## **SERVICE BULLETIN** SB98.10

Machines/Models:MX Series

PURPOSE: Inspect both rear spindle/chassis welds.

Figure 1

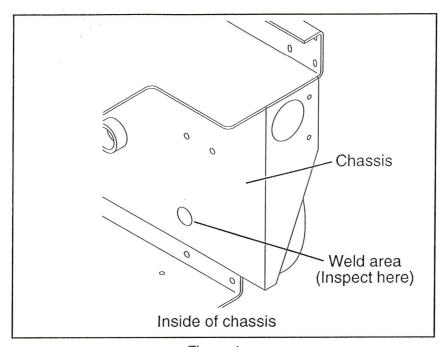
1. Visually inspect both rear spindle/chassis welds (Figure 1). Verify both rear spindle/chassis welds are free of cracks. NOTE: If a weld crack is present continue to step 2. If no weld cracks are present continue to step 4.

- 2. Grind cracked weld from spindle/chassis area (Figure 1).
- 3. Reweld spindle to chassis (Figure 1).

Figure 2

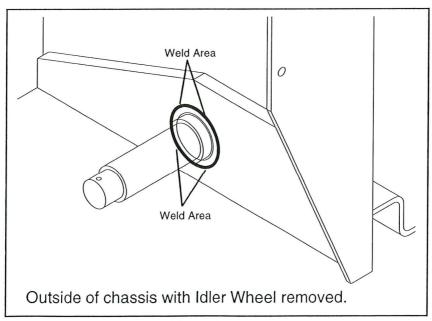
- 4. Remove cotter pins, slotted nuts and idler wheels.
- 5. Weld spindles to chassis as instructed (Figure 2).
- 6. Reinstall idler wheels and slotted nuts. Torque slotted nuts to 75 ft/lbs (102 Nm). Install new cotter pins. **DO NOT** back off nut to install cotter pins.
- 7. Remove support stands, lower jack and remove.
